Description Photograph(s) 4-G04

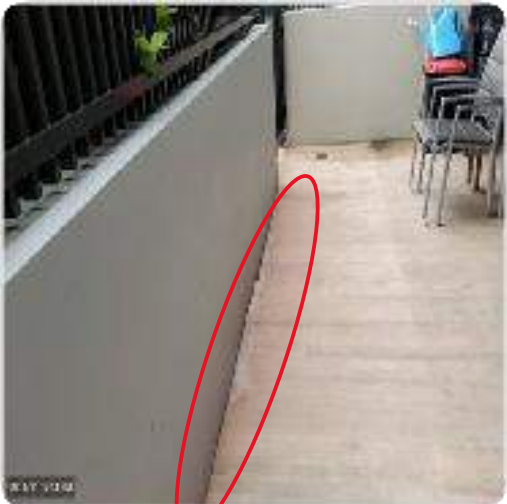
| ITEM | COMMENTARY | PHOTOGRAPH(S) |
|-------|--|---|
| A | <p>Location & Description Bedroom 2 – Rainwater penetration</p> <p>The Author has observed moisture penetration, damage, and high levels of moisture indicated to the southeast corner and western side sliding door to bedroom 2.</p> <p>The Author noted issue was identified in TCA (Giaouris) report Attachment F Defect schedule U G05.20</p> <p>The Author observed that –</p> <ul style="list-style-type: none"> the cavity drainage (weep hole) at concrete slab level above the eastern side of sliding door has been painted over. No water stop has been provided to the sliding door <p>The Author conducted moisture test to the exterior wall at the main entry ramp adjoining bedroom 2 and observed high level of moisture indicated.</p> <p>The Author is of the view that –</p> <ol style="list-style-type: none"> Rainwater is penetrating the western end of the sliding door due the Builders failure to provide a water stop in accordance with AS4654.2. Moisture penetrating the southeast corner of bedroom 2 has originated due the Builders failure to provide weep drainage to the HEBEL wall system in accordance with the manufacturers guidelines. The has failure to adequately weatherproof the parapet wall above as identified in Item C-2 of this report. |  <p>Moisture penetration, mould and damage to southeast corner of bedroom 2</p> |

| <p>C</p> | <p>Breach(es) <i>Failure to comply with the following:</i></p> <ul style="list-style-type: none"> ▪ Home Building Act 1989 (NSW) under Section 18B Clauses 1 (a); ▪ National Construction Code 2016 Vol1 FP1.4 Weatherproofing ▪ AS4654.2:2012 ▪ Manufacturers guidelines ▪ Contract plans and specifications |  |

| <p>D</p> | <p>Proposed Rectification Scope of Works Allow to: IN CONJUNCTION WITH RECTIFICATION WORKS IN RELATION TO ITEM C-2</p> <ol style="list-style-type: none"> 1. Provide site supervision. Supervisor to coordinate access and facilitate the works throughout the whole process. 2. Gain access to required areas in accordance with Safework requirements. 3. Cover and protect adjacent surfaces during the rectification work 4. Labour to remove sliding door and store in a secure location 5. Labour to clean down existing waterproofing, reactivate waterproofing, install new waterproofing waterstop angle behind sliding door, aluminium angle colour matched to aluminium frame, Install new waterproofing, angle and fillet to hob and waterstop 6. Labour to reinstall sliding door suite, finishes, sealant to vertical and horizontal tile junction, Install storm moulds to sliding door frame 7. Labour to complete paint repair affected finishes 8. Supply paint ancillaries 9. Remove damage carpet, supply and install new carpet 10. Make good any surfaces affected as part of the works, to their prior condition. 11. Clean site and leave in a tidy condition upon completion of work 12. Waste disposal | |

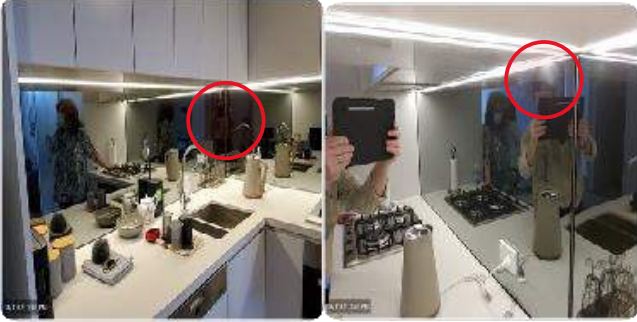
| ITEM | COMMENTARY | PHOTOGRAPH(S) |
|-------|---|--|
| C | <p>Breach(es) Failure to comply with the following:</p> <ul style="list-style-type: none"> Home Building Act 1989 (NSW) under Section 18B Clauses 1 (a) Building contract – Defect liability period | |

| ITEM | COMMENTARY | PHOTOGRAPH(S) |
|-------|---|--|
| D | <p>Proposed Rectification Scope of Works Allow to:</p> <ol style="list-style-type: none"> Provide site supervision. Supervisor to coordinate access and facilitate the works throughout the whole process. Gain access to required areas in accordance with Safework requirements. Cover and protect adjacent surfaces during the rectification work. Labour to fix loose mixer tap handle Make good any surfaces affected as part of the works, to their prior condition. Clean site and leave in a tidy condition upon completion of work |  |

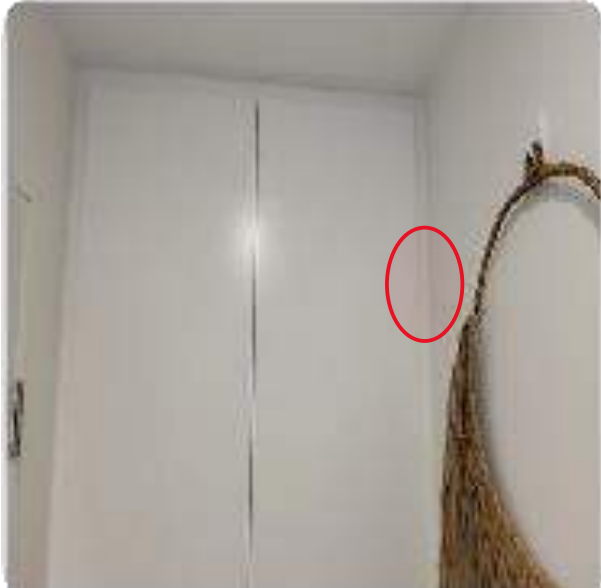
| ITEM | COMMENTARY | PHOTOGRAPH(S) | |
|-------|--|---|--|
| C | <p>Breach(es) <i>Failure to comply with the following:</i></p> <ul style="list-style-type: none"> Home Building Act 1989 (NSW) under Section 18B Clauses 1(a) AS2311:2017 Guide to the painting of buildings NSW standards & tolerances 2017 – 13.2 Surface finish of paintwork <i>Paintwork is defective if the application has blemishes such as paint runs, paint sags, wrinkling, dust, bare or starved painted areas, colour variations, surface cracks, irregular and coarse brush marks, sanding marks, blistering, non-uniformity of gloss level and other irregularities in the surface that are visible from a normal viewing position. (Highlighting added)</i> | | |

| ITEM | COMMENTARY | PHOTOGRAPH(S) | |
|-------|--|---|--|
| D | <p>Proposed Rectification Scope of Works Allow to:</p> <ol style="list-style-type: none"> Provide site supervision. Supervisor to coordinate access and facilitate the works throughout the whole process. Gain access to required areas in accordance with Safework requirements. Cover and protect adjacent surfaces during the rectification work. Labour to patch, repair and apply paint in accordance with AS2311:2017 Guide to the painting of buildings Supply paint and ancillaries Make good any surfaces affected as part of the works, to their prior condition. Clean site and leave in a tidy condition upon completion of work | | |

Extract from construction architectural drawings showing subject wall removed by lot owner

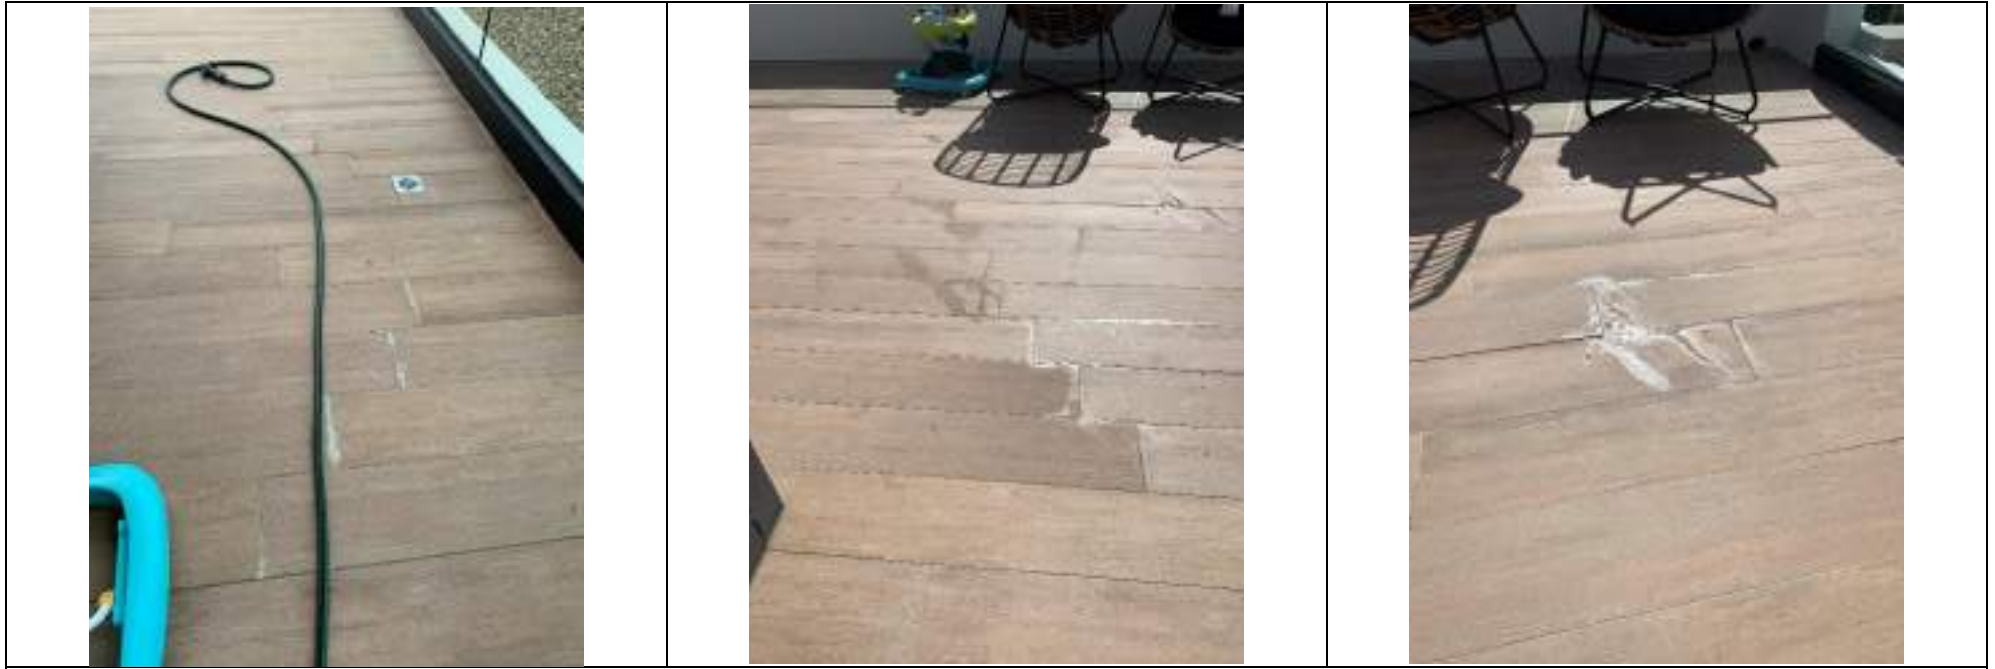
| <p>C</p> | <p>Breach(es) <i>Failure to comply with the following:</i></p> <ul style="list-style-type: none"> ▪ <i>Home Building Act 1989 (NSW) under Section 18B Clauses 1(a) & (f)</i> | |

| <p>D</p> | <p>Proposed Rectification Scope of Works Allow to:</p> <ol style="list-style-type: none"> 1. Provide site supervision. Supervisor to coordinate access and facilitate the works throughout the whole process. 2. Gain access to required areas in accordance with Safework requirements. 3. Provide material hoist to balcony terrace level 4. Cover and protect adjacent surfaces during the rectification work. 5. Labour to remove furniture, spa and affected fixtures and place in secure location 6. Provide waste chute to balcony terrace level to remove demolition and building material waste from balcony 7. Labour to demolish and remove tiling, tile bed (screed), and waterproofing membrane, expose concrete slab substrate, remove demolition waste and place in waste bin for disposal 8. Labour to grind concrete surface and prepare surface for new waterproofing system 9. Labour to provide proprietary waterproofing system in accordance with AS4654.1&2 to balcony terrace 10. Labour to carry and load materials throughout remediation works 11. Labour to place sand and cement tile screed and provide positive falls to drainage inlets in accordance with AS3958.1 and in accordance with building contract specifications 12. Labour to mix sand and cement for tile screed and assist trades 13. Supply sand and cement for tile screed 14. Supply 'Efflock' to prevent efflorescence 15. Supply and apply waterproofing system on top of tile bed to prevent efflorescence 16. Supply and install preformed tile movement joint in accordance with AS3958.1 and building contract specifications 17. Supply and fix new selected tiles and grout in accordance with AS3958.1:2007 and building contract specifications | |

18. Supply 'Efflock' for tile adhesive and grouts to prevent efflorescence
19. Labour to seal all joints and junctions
20. Supply sealants
21. Remove and dispose of all building waste
22. Make good any surfaces affected as part of the works, to their prior condition.
23. Labour to restate spa, furnishing and fixtures
24. Clean site and leave in a tidy condition upon completion of work
25. Dispose of building waste

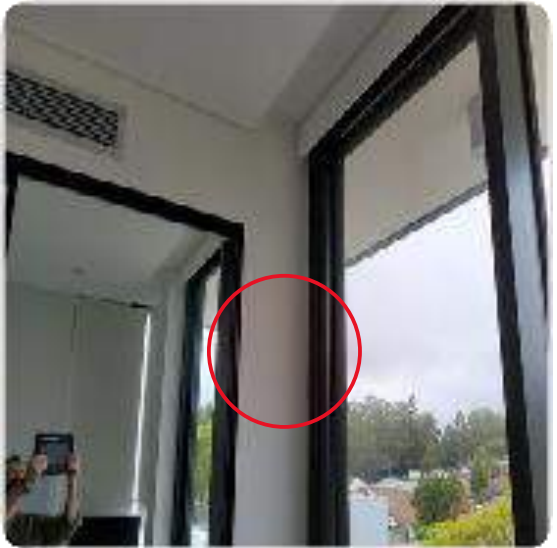
| ITEM | COMMENTARY | PHOTOGRAPH(S) |
|-------|---|---|
| C | <p>Breach(es) Failure to comply with the following:</p> <ul style="list-style-type: none"> ▪ Home Building Act 1989 (NSW) under Section 18B Clauses 1 (a); ▪ Fair Trading Guide to Standards & Tolerances 2017 10.18 Peaking or jointing in plasterboard - <p>10.18 Peaking or jointing in plasterboard Plaster peaking or jointing is defective if it is visible from a normal viewing position⁵.</p> | |

| ITEM | COMMENTARY | PHOTOGRAPH(S) |
|-------|---|---|
| D | <p>Proposed Rectification Scope of Works Allow to:</p> <ol style="list-style-type: none"> 1. Provide site supervision. Supervisor to coordinate access and facilitate the works throughout the whole process. 2. Gain access to required areas in accordance with Safework requirements. 3. Cover and protect adjacent surfaces during the rectification work. 4. Labour to patch, repair and apply paint in accordance with AS2311:2017 Guide to the painting of buildings 5. Supply paint and ancillaries 6. Make good any surfaces affected as part of the works, to their prior condition. 7. Clean site and leave in a tidy condition upon completion of work | |

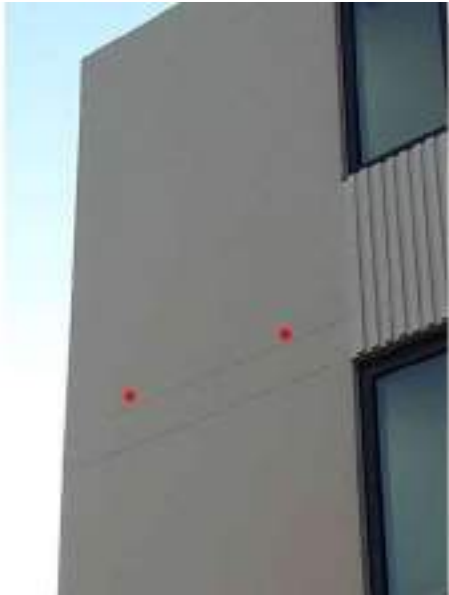
| DEFECT NO. | LOCATION | AREA | BREACH | PHOTOGRAPH | DEFECT DESCRIPTION |
|------------|-------------|----------|--|---|---|
| C 20 | East facade | Cladding | See sections 8.5 and 8.6 of this report. |  | <p>Crack</p>  <p>HARPER OBSERVATIONS AND COMMENTS – CONCUR, OUTSTANDING, REFER ITEM C-6 SECTION 10 HARPER DEFECT SCHEDULE.</p> |

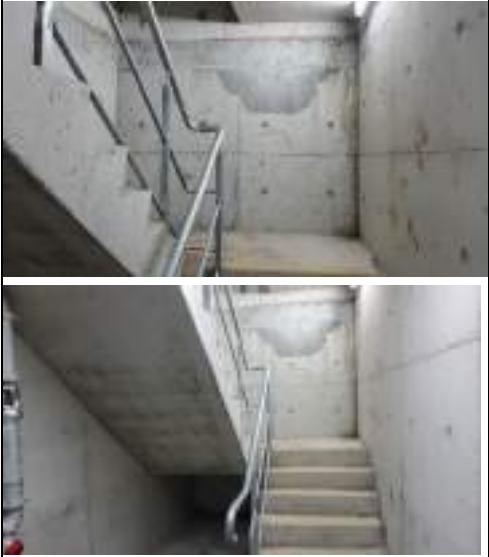
| DEFECT NO. | LOCATION | AREA | BREACH | PHOTOGRAPH | DEFECT DESCRIPTION |
|------------|------------|---------------------------------------|----------------------------------|---|---|
| C 70 | Basement 1 | North east fire stair to ground level | See section 8.15 of this report. |  | <p>No nosing or compliant non-slip finish</p>  <p>HARPER OBSERVATIONS AND COMMENTS –OUTSTANDING REFER ITEM FS-1 SECTION 10 HARPER DEFECT SCHEDULE</p> |

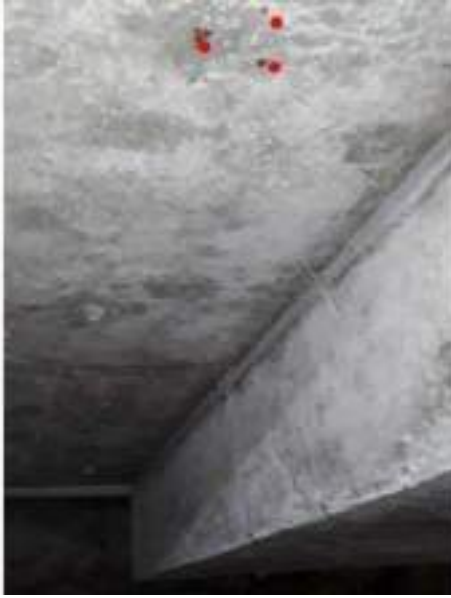
| DEFECT NO. | LOCATION | AREA | BREACH | PHOTOGRAPH | DEFECT DESCRIPTION |
|------------|------------|----------------|----------------------------------|---|--|
| C120 | Basement 2 | Parking bay 13 | See section 8.20 of this report. |  | Insufficient vibration of concrete. HARPER OBSERVATIONS AND COMMENTS –RESOLVED |

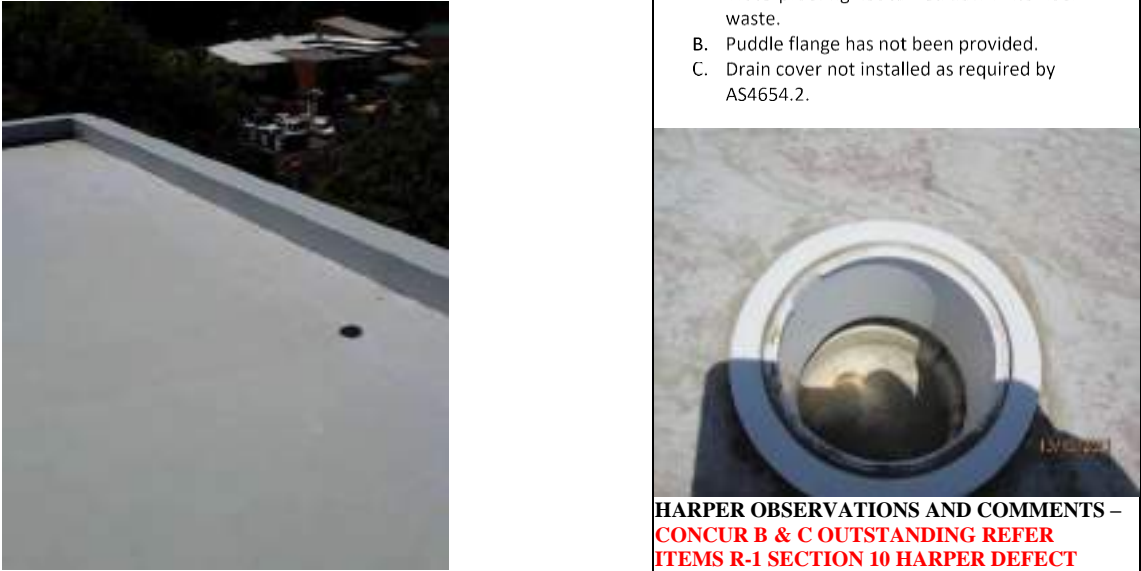
| DEFECT NO. | Building L LOCATION | Facade AREA | Note. BREACH | | <p data-bbox="1615 169 1854 185">Roof covered with pebbles</p>  <p data-bbox="1615 459 2101 528">HARPER OBSERVATIONS AND COMMENTS – OUTSTANDING REFER ITEM C-2 SECTION 10 HARPER DEFECT SCHEDULE.</p> |
|------------|------------------------|------------------|---------------------------|--|---|
| C 143 | Main switch room | Slab penetration | Fire engineer to inspect. |  | |
